OJAI UNIFIED SCHOOL DISTRICT

BID ADDENDUM NO. 2 ISSUED 11/27/2019

REROOFING PROJECT AT NORDHOFF HIGH SCHOOL PROJECT NO. 2019-1713

ADDENDUM NO. 2

G-000

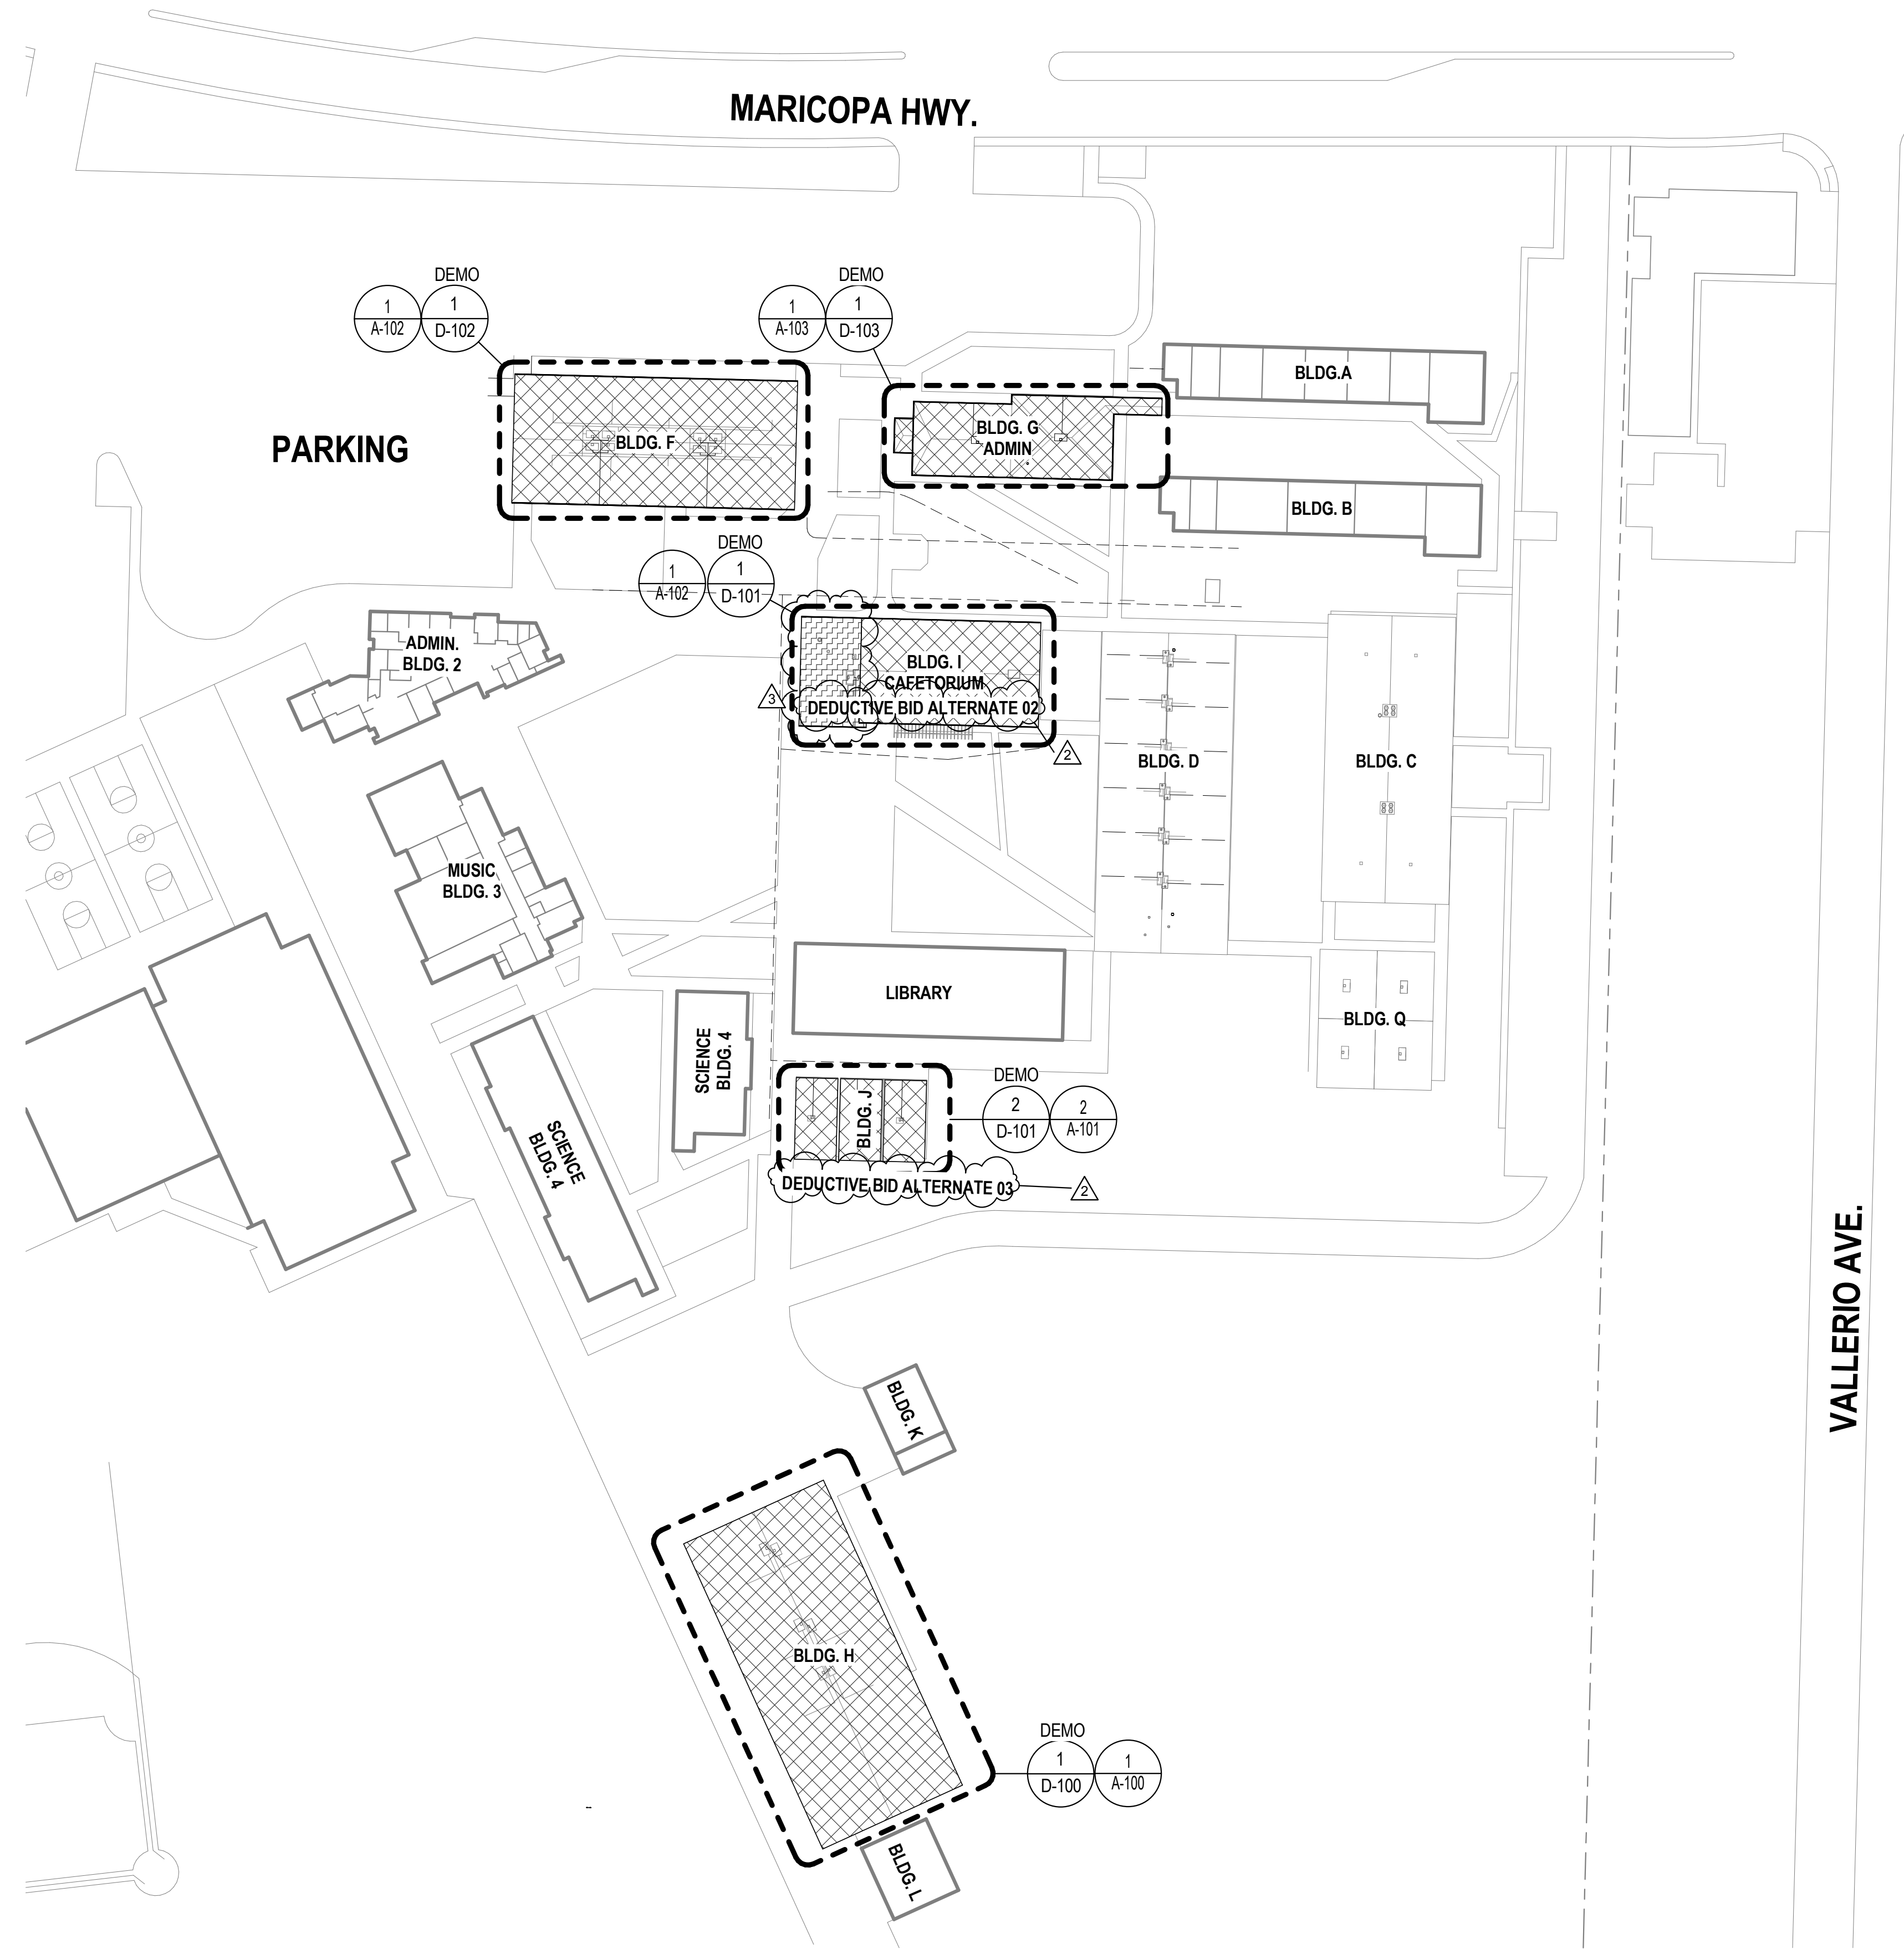
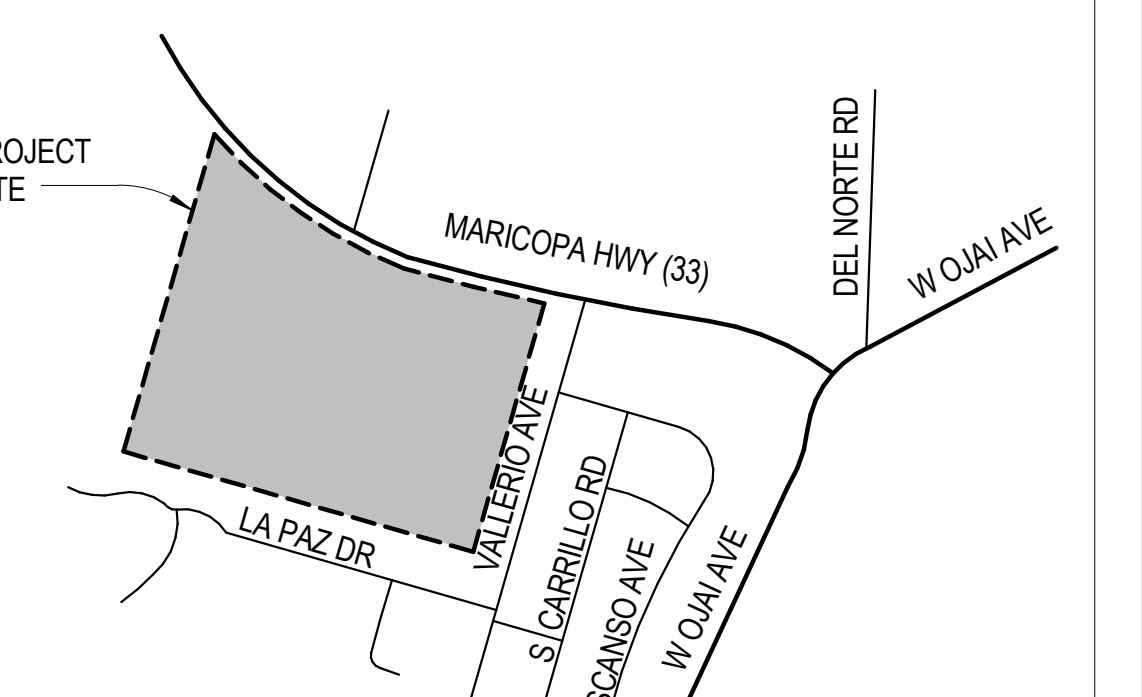
- Item 1. Drawings coordinated to show altered roof scope of Building I's lower which will be recoated and not replaced.
- o G-000 Title Sheet: Project Description Revised
 - o AS-100 Site Plan: Building I lower roof hatch revised.
 - o D-101 Building I & J – Roof Demolition Plans: Building I lower roof marked as recoating project and to remain and not be demolished.
 - o A-101 Building I & J – Roof Plans: Building I lower roof marked as recoating project. Callouts for roof details removed as required for coordination. Scope for connection of downspouts to underground storm drain line at south of cafeteria removed from this project as that work is already complete.
 - o 071326 Sec 3.4: A-1 Grit Arctic White or equal roofing granules to be embedded in White Star Roof Coating throughout all sections at 35 lbs. per 100 SF

RECOAT LOWER ROOF OF BUILDING I
